Response to submission report 2A Gregory Place, Harris Park, NSW, 2150

Submitted to Department of Planning, Housing and Infrastructure
August 2025

Figure 25 Ariel view of south boundary childcare location

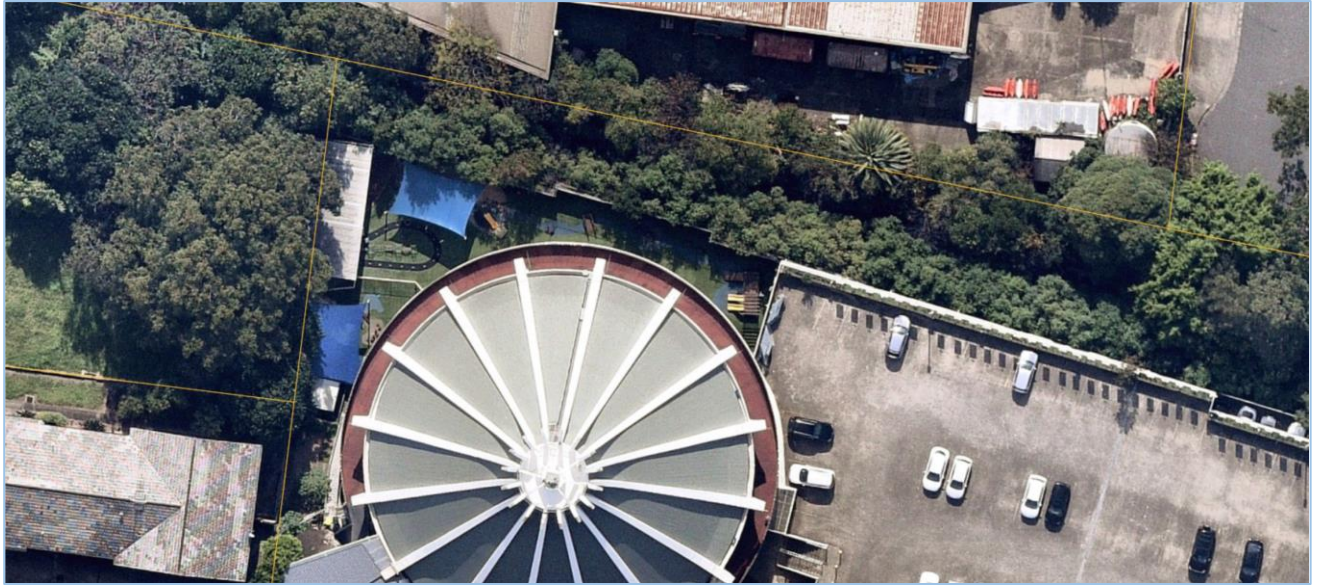
- *The Department has identified that the proposal would result in significant overshadowing impacts on the childcare centre known as ‘Young Academics Early Learning Centre’. Section 4.11 of the NSW Child Care Planning Guide requires outdoor play areas for childcare centres to have “have year-round solar access to at least 30 per cent of the ground area, with no more than 60 per cent of the outdoor space covered”. The childcare centre is located directly to the south of the site (as highlighted in yellow below). The submitted shadow diagrams indicate that Buildings B and C would restrict the childcare’s sunlight access to less than 1 hour per day mid-winter. The Department requires that overshadowing impacts are sufficiently reduced to demonstrate that no significant additional overshadowing of the childcare centre would occur as a result of the development. Further setbacks for buildings adjoining the canal in combination with a reduction in height may address this issue.*

- Section 3.5 of the Child Care Planning Guideline states that “Visual privacy is about allowing residents on adjacent properties to occupy their private space without being overlooked by child care facilities and ensuring child care facilities are not overlooked by neighbouring properties”. Provide a view diagram demonstrating that direct line of sight into the adjacent childcare centre would not occur from south facing apartments or the “Link Terrace” of building A.

Figure 26 Tree locations

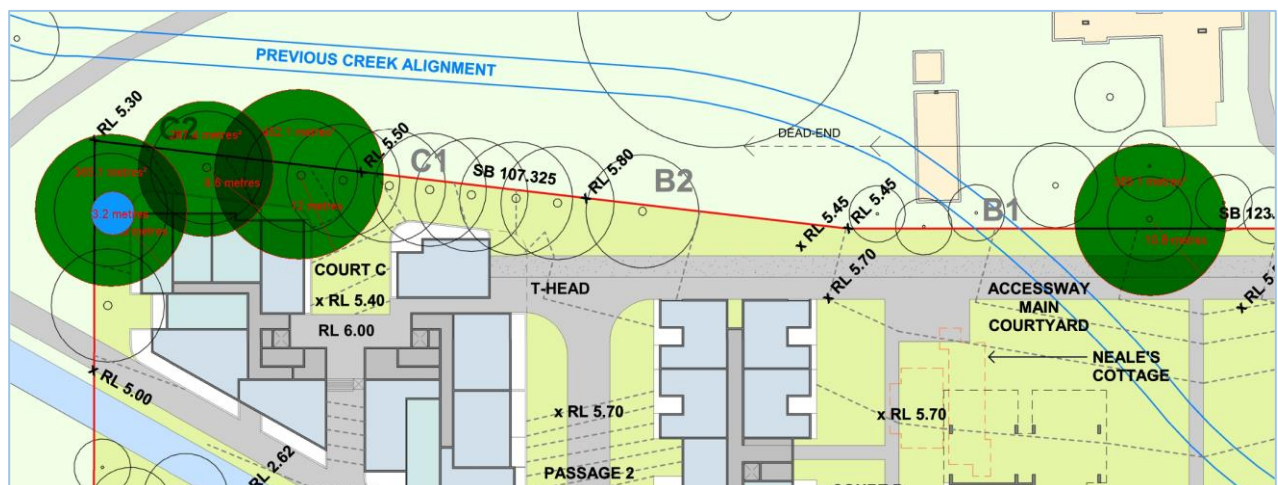
- *The Department has identified that trees may not be able to be retained (that are identified to be retained) as they are in close proximity to the building envelopes of Building A and C, the proposed basement, and the internal accessway/emergency driveway. The submitted architectural plans indicate that some trees to be retained would have incursions into their tree protection zones (TPZ) of more than 10% (a major encroachment under AS 4970-2009 Protection of trees on development sites). Their canopies would also require significant trimming, and some trees may have incursions into the structural root zones (SRZ). The European heritage report, community consultation report, wind report, and view analysis all emphasise the importance of these trees being retained.*

The attached Arboricultural Impact Assessment report has been updated to clearly identify tree numbers, tree protection fencing, tree canopy pruning requirements and a discussion on the level of impact on trees.

The building design and setbacks have been updated with TPZ setbacks improved with respect to the separation of site and adjoining trees to the proposed building envelope, basement location and excavations and scope of works from the trees proposed to be kept.

Figure 28 Temporary access

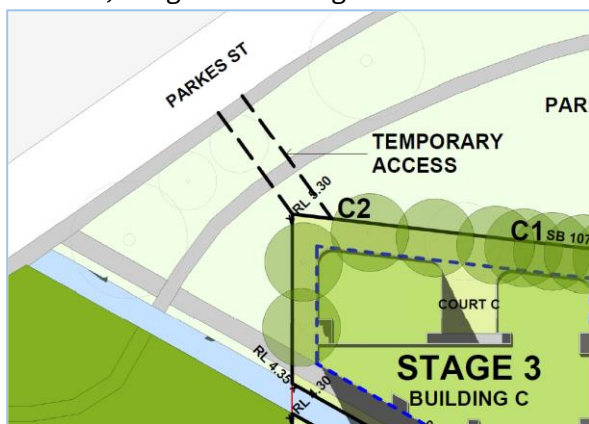
The architectural plans indicate that temporary access to the north-west portion of the site would be provided via Parkes Street. This location on the site is proposed to have tree protection fencing. In addition, the general storage of materials is recommended outside of a retained TPZ.

Figure 29 Clay Cliff channel set backs

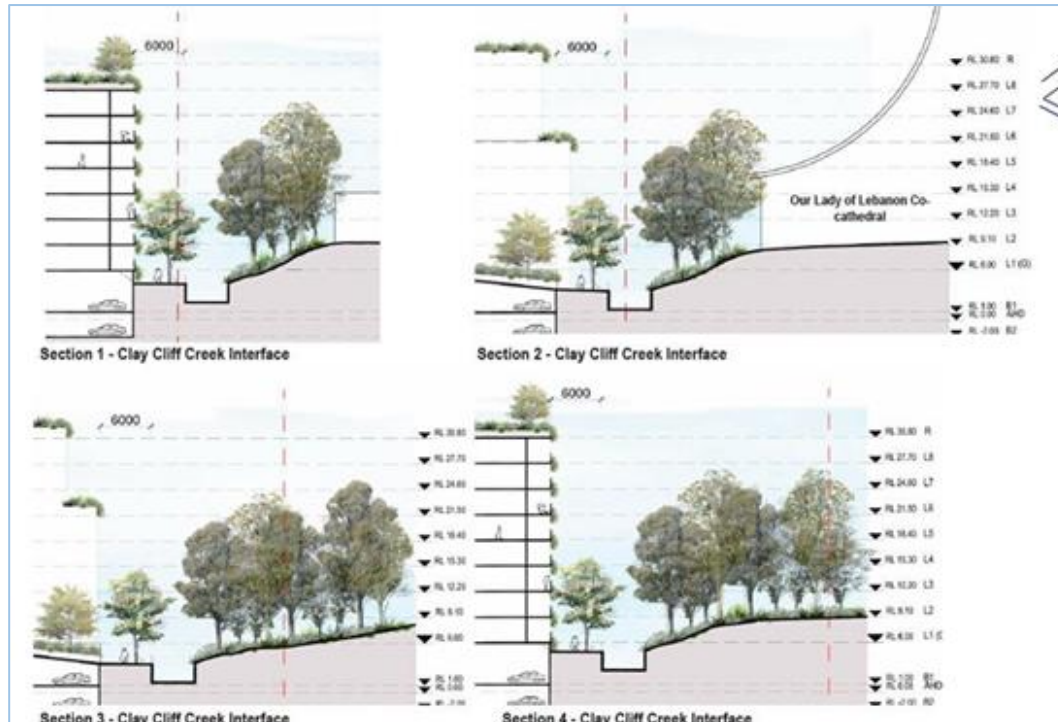
- j. It is noted that creek bank along the subject site has been proposed to be engineered vertical wall as shown in the snapshot from landscape plans. Council does not support this type of bank treatment for natural creek.*

Action: Riparian Area needs to be appropriately treated and planted to prevent any potential erosion in major flood events. Stormwater channel/creek belongs to Sydney Water and hence any works needs to be approved by Sydney Water.
